Access Compliance Report

Public Rights-of-Way

(Curb Ramps)

Intersection ID: 22328	Main Street: PARK_RD	Cross Street: SURRY_RIDGE_CT	Location: SE
ADA ID: C69C3A80CEE8	Ramp Type: PerpDiag	Initial Pass/Fail: Fail	Overall Compliance: No
		Severity Score: 25

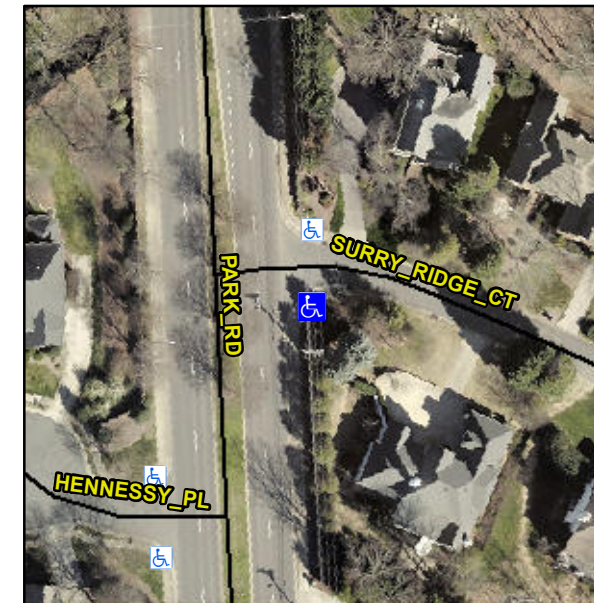
Not Found, R304.2.2, R304.5.3

Remove & Replace Curb Ramp With Two New Directional Ramps or Equivalent.
